PLAN AND ZONING COMMISSION MEETING

CITY OF DAVENPORT, IOWA

TUESDAY, NOVEMBER 16, 2021; 5:00 PM

Case P21-06: Request of C&L Plaza for a preliminary plat of Prairie Pointe 2nd Addition for a 45-lot subdivision on 19.26 acres, located north of East 58th Street and east of Eastern Avenue.
[Ward 8]

PRELIMINARY PLAT
PRAIRIE POINTE
2nd ADDITION
TO THE CITY OF DAVENPORT, IA

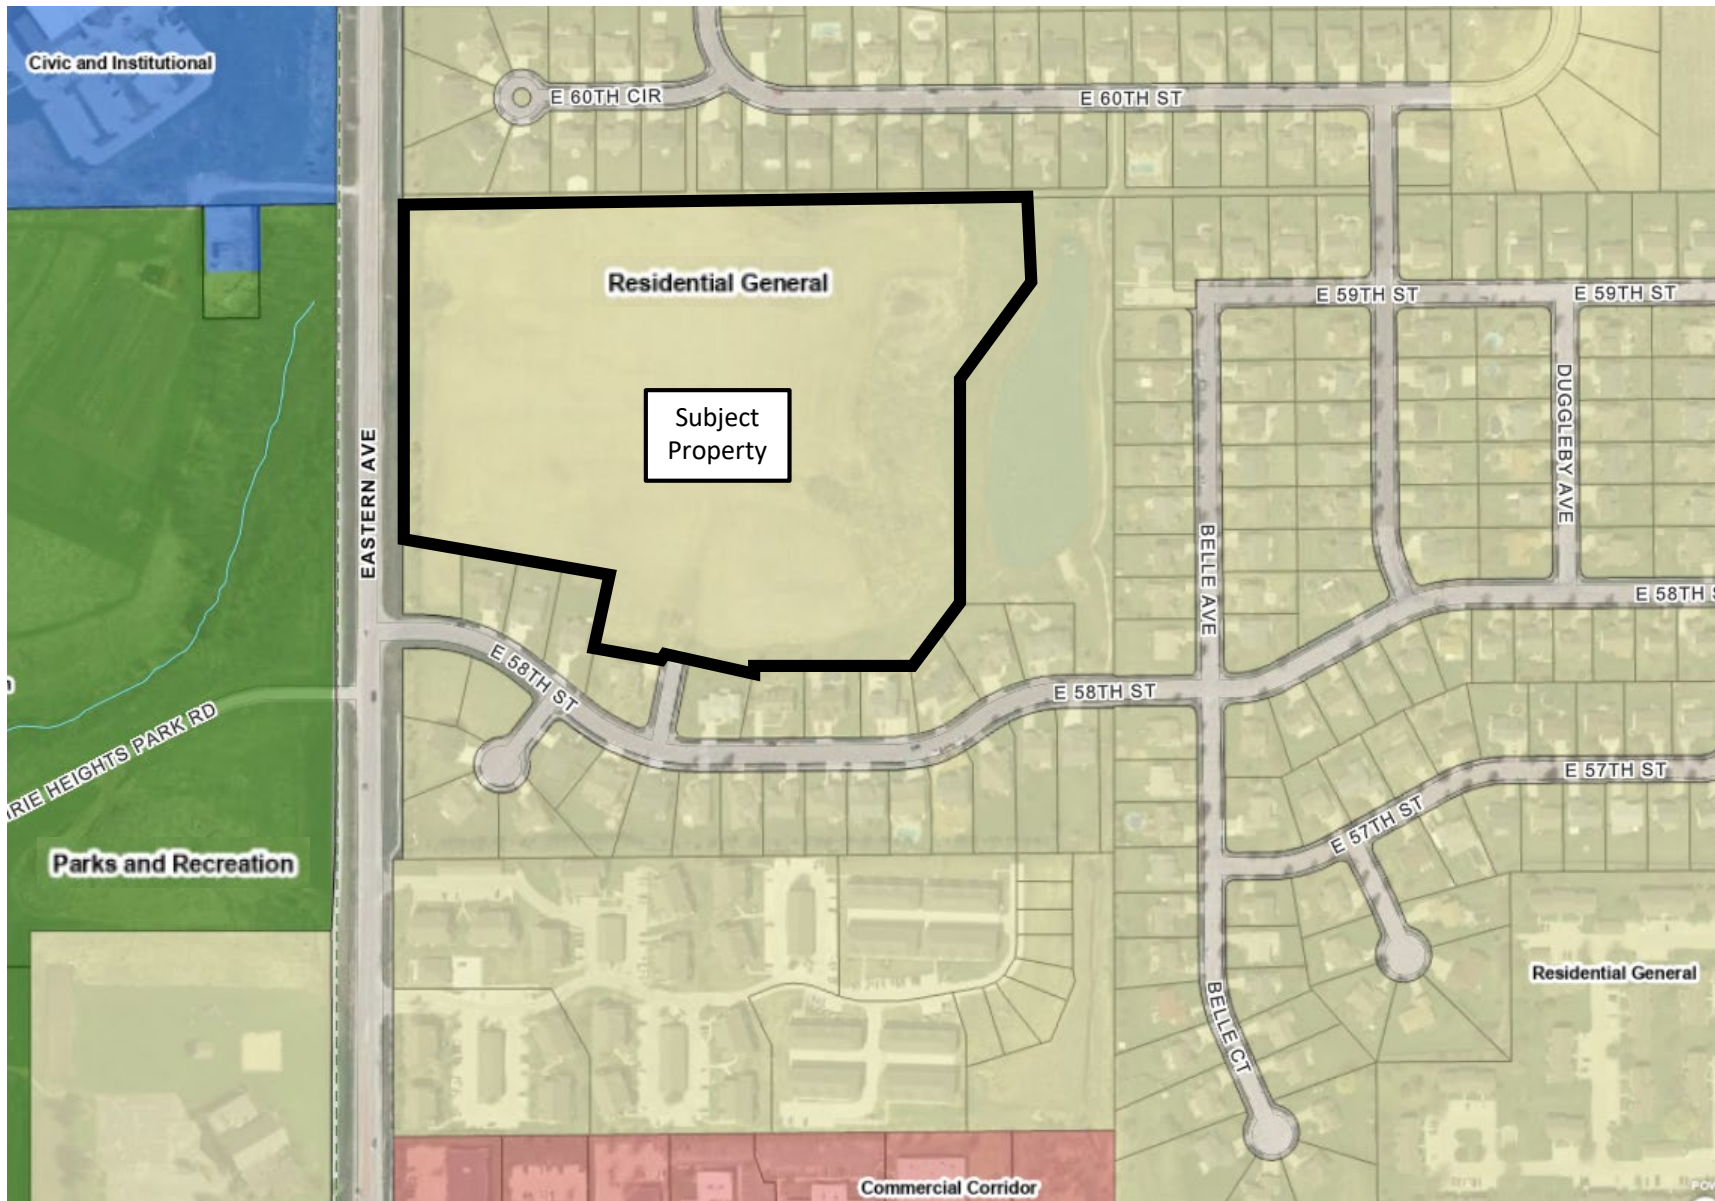
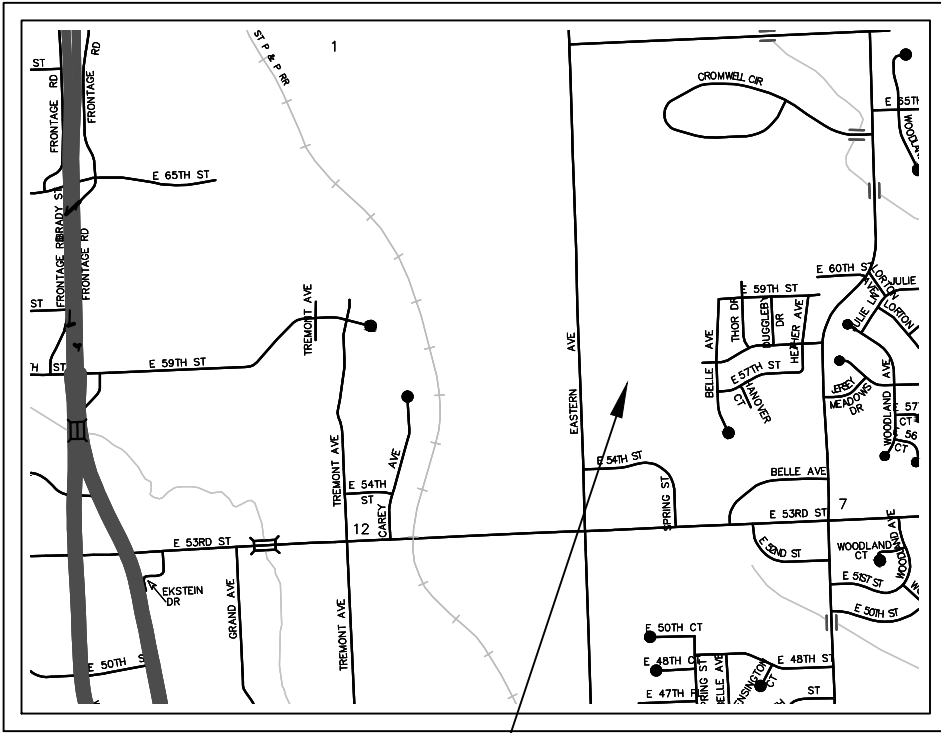
1. Standard Plat Notes shall be added.
2. Katelyn Court shall be renamed to East 59th Street.
3. Add a note stating, "Sidewalks shall be constructed along all street frontages prior to the completion of residential construction for each lot, or as so ordered by the City of Davenport. Sidewalks along Eastern Avenue street frontage shall be constructed prior to the completion of roadway paving operations."
4. Cul-de-sacs are to be designed and dimensioned per SUDAS Design Manual Section 5C-2.0. Increase the cul-de-sac right-of-way radii to 56.5 feet.
5. Additional storm and sanitary sewer easements shall be required based on preliminary engineering of conceptual plans including service drainage of the property to the west.
6. On-street parking shall be limited to one side of the street. No parking will be permitted within the cul-de-sacs.

WEST LAKE BUSINESS PARK
5TH ADDITION

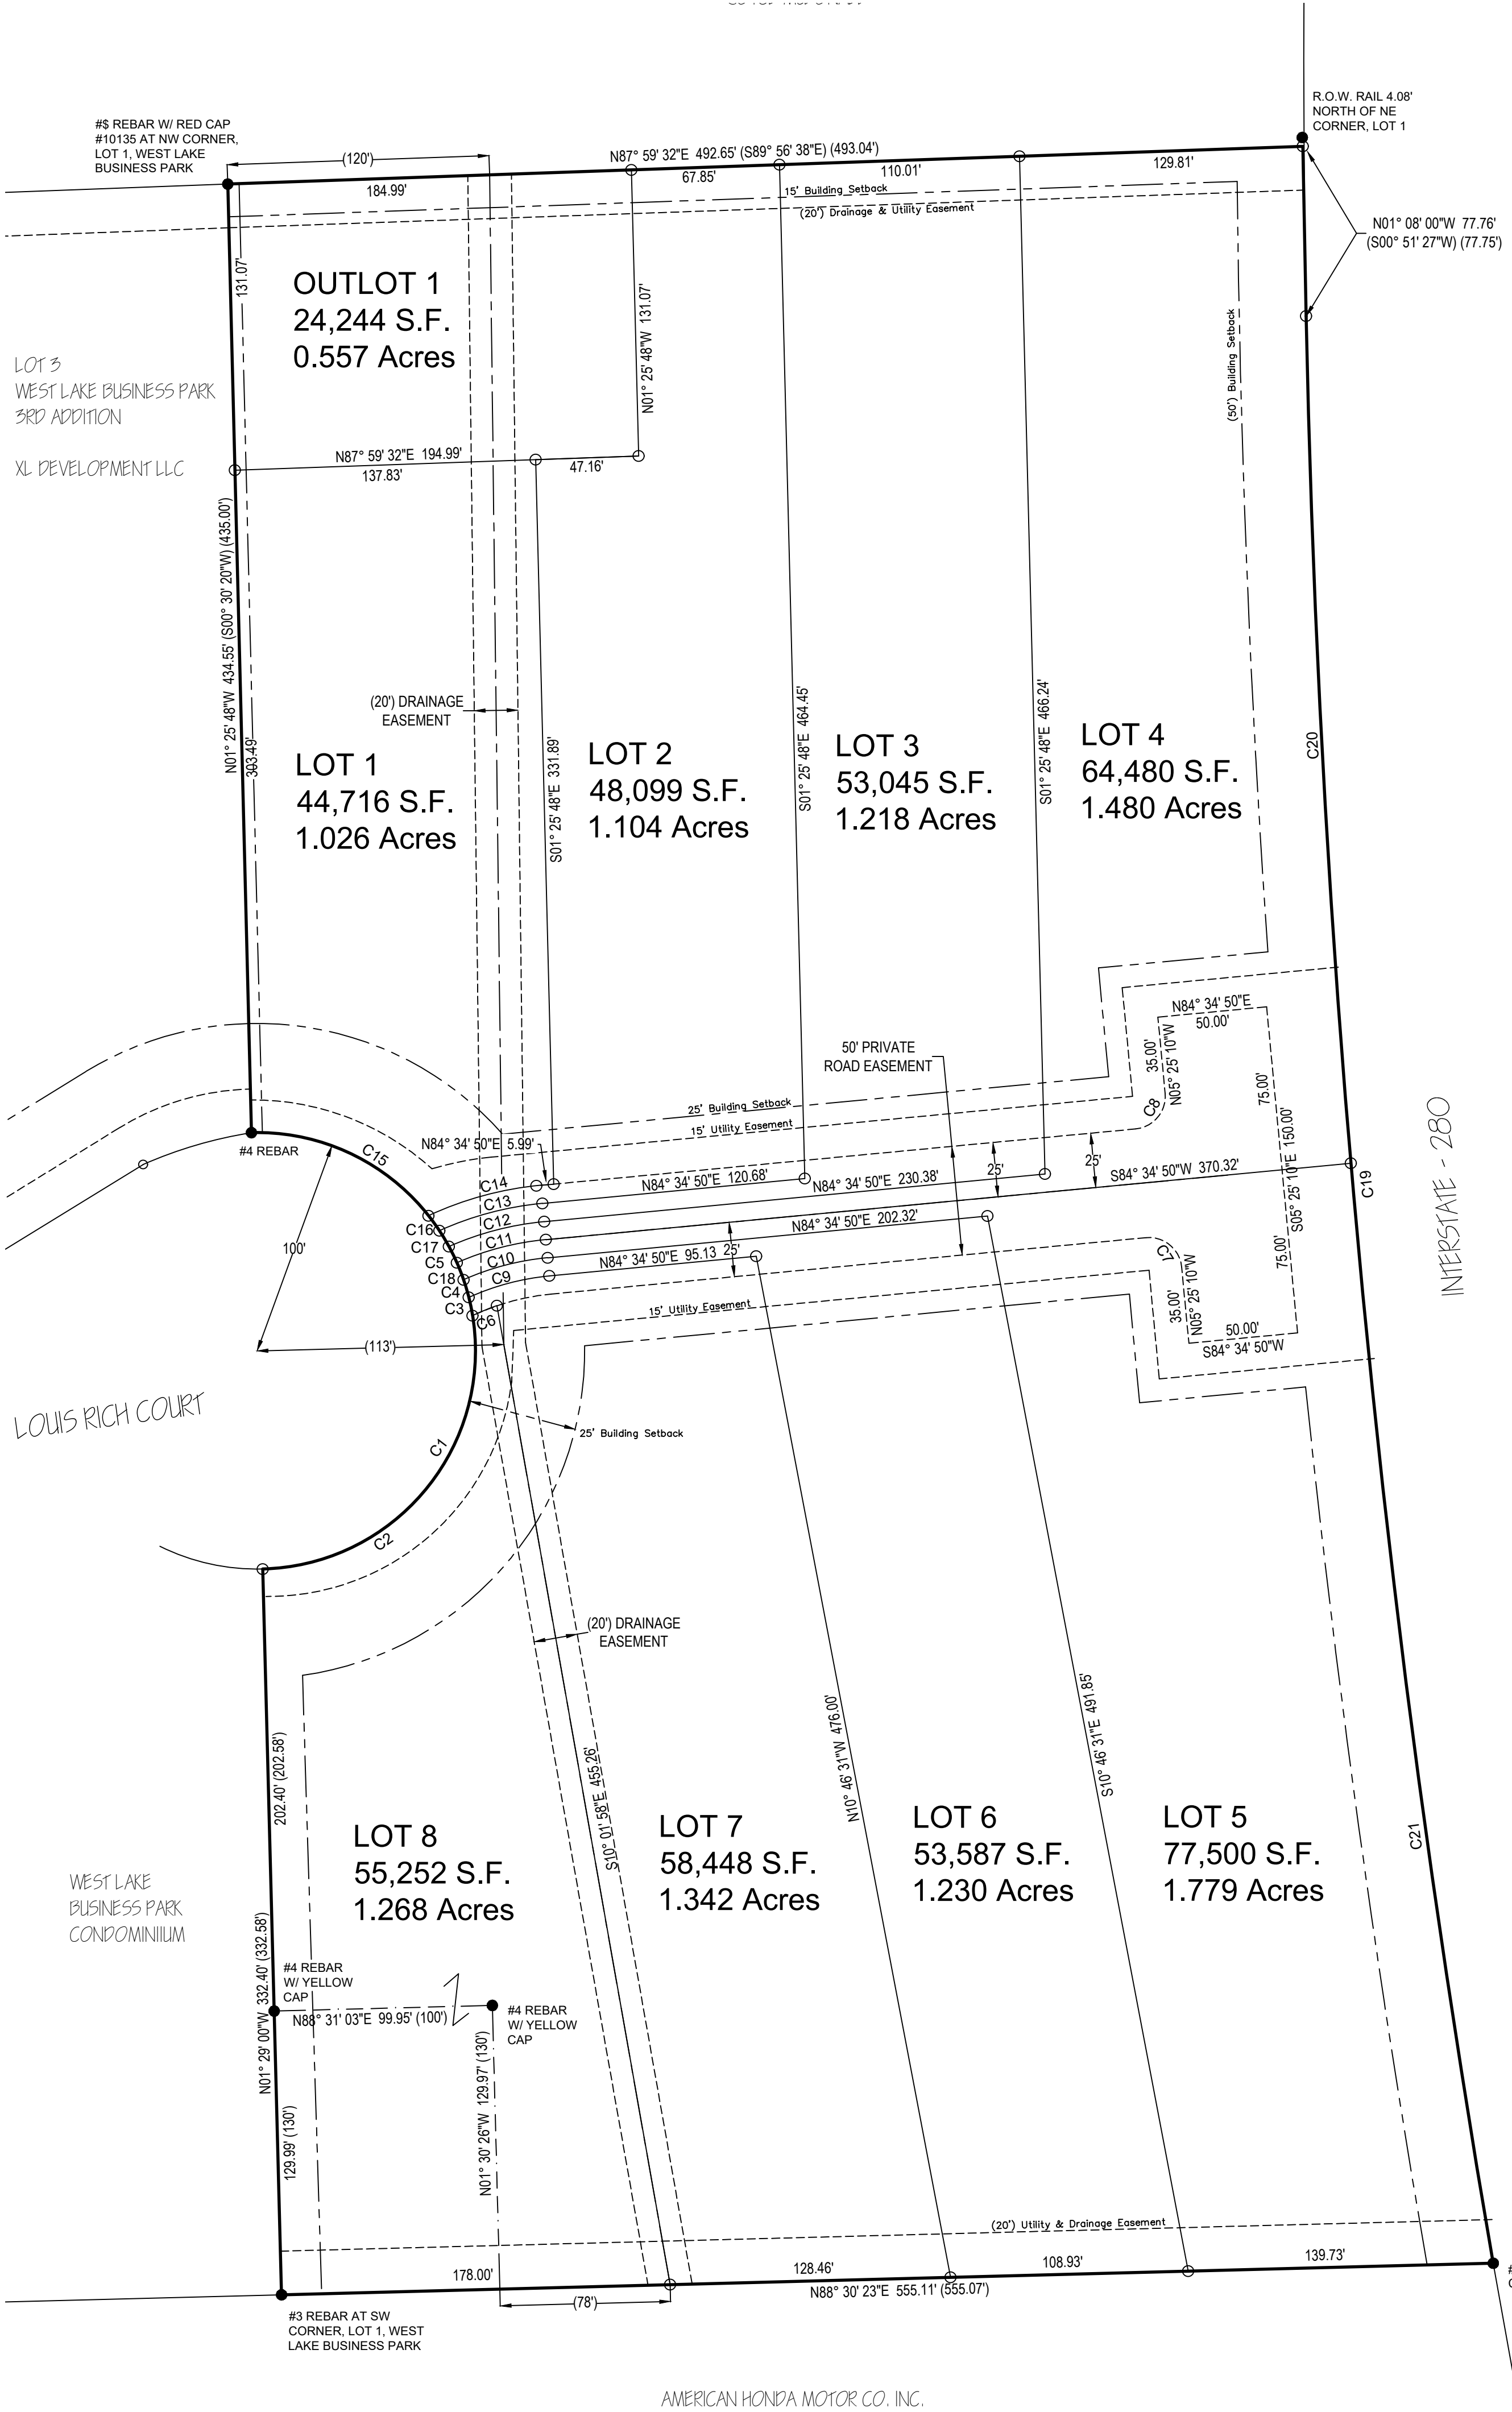
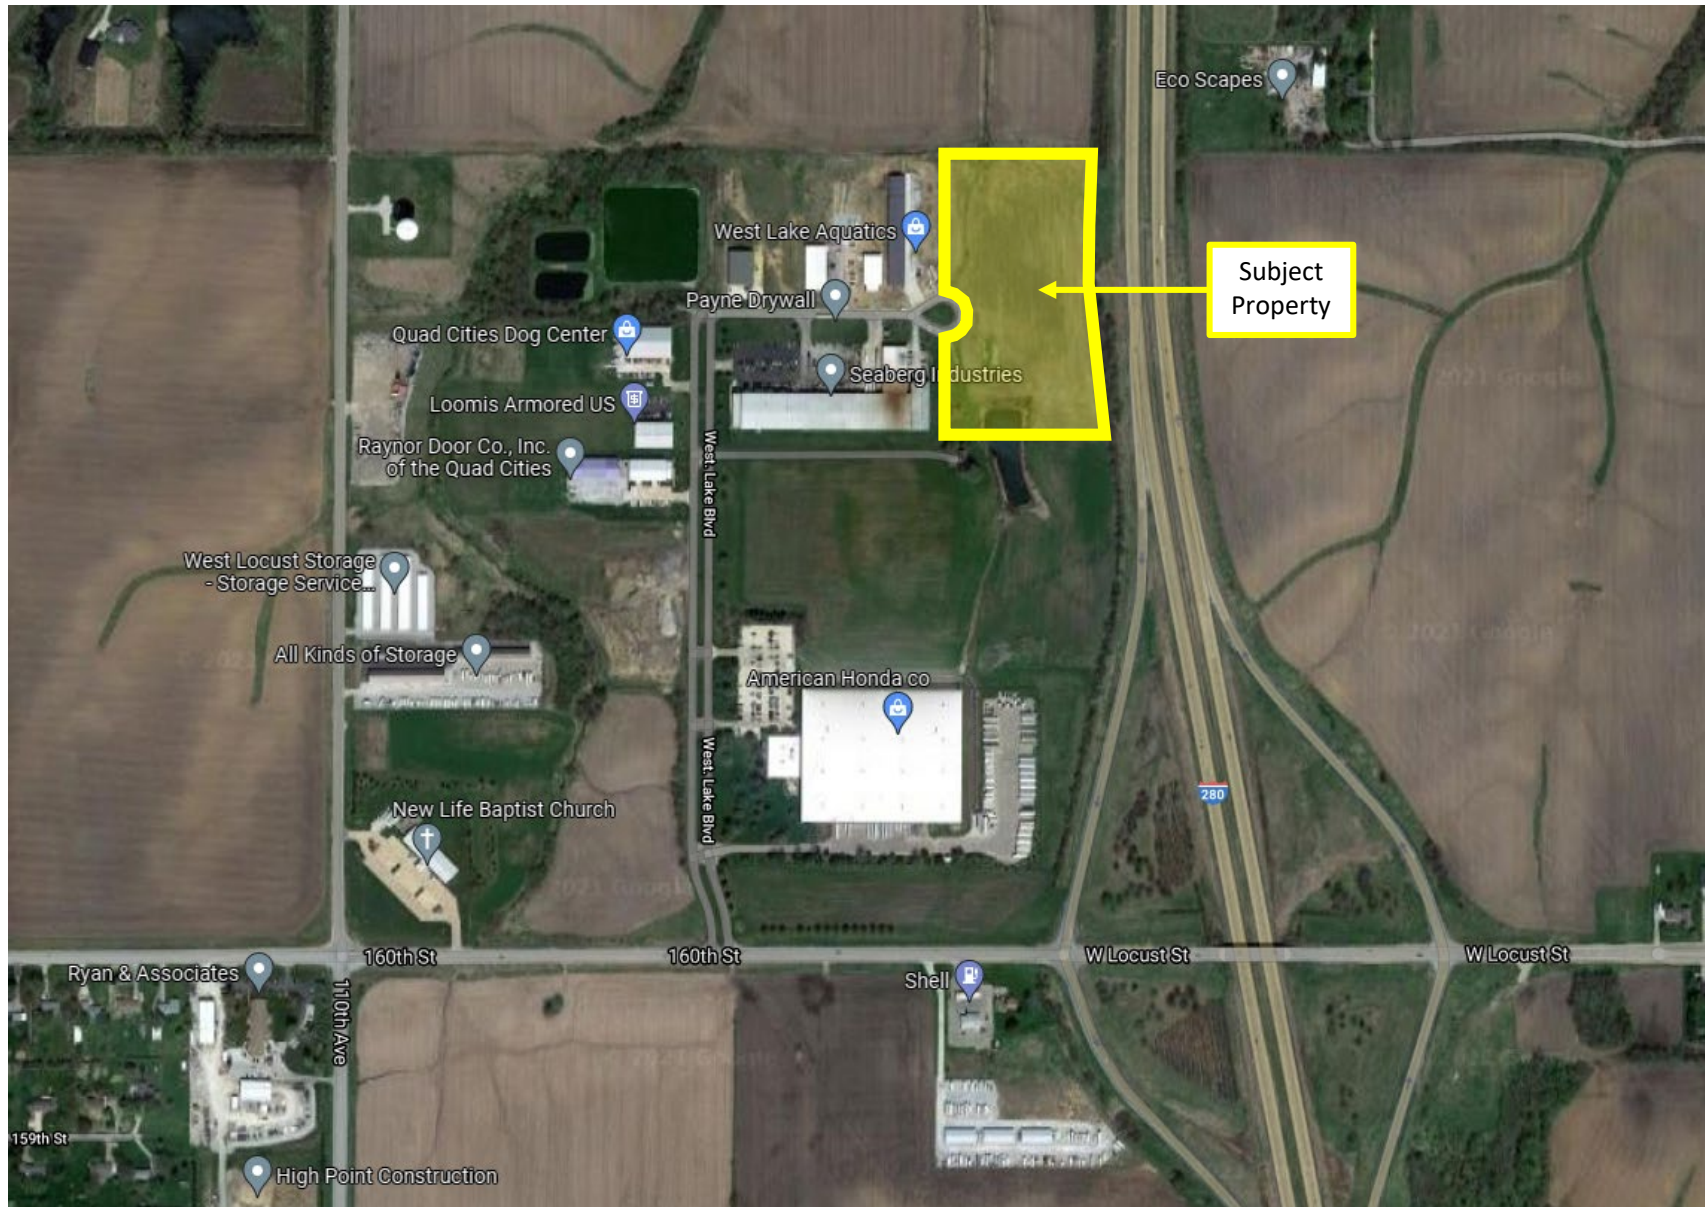
1. That the surveyor signs the plat.
2. That the utility providers sign the plat when their easement needs have been met.
3. Add an approval signature line for Metronet.
4. Rename "Outlot 1" to "Outlot A". Provide a note stating the purpose of the outlot.
5. Include a note stating, "Drainage easements shall not be impeded."
6. Add a drainage easement to carry flow from the I-280 culvert. A grading plan shall confirm that the culvert flow is maintained.
7. Relabel the 20 foot drainage easement as "Sewer, Drainage, and Access Easement".
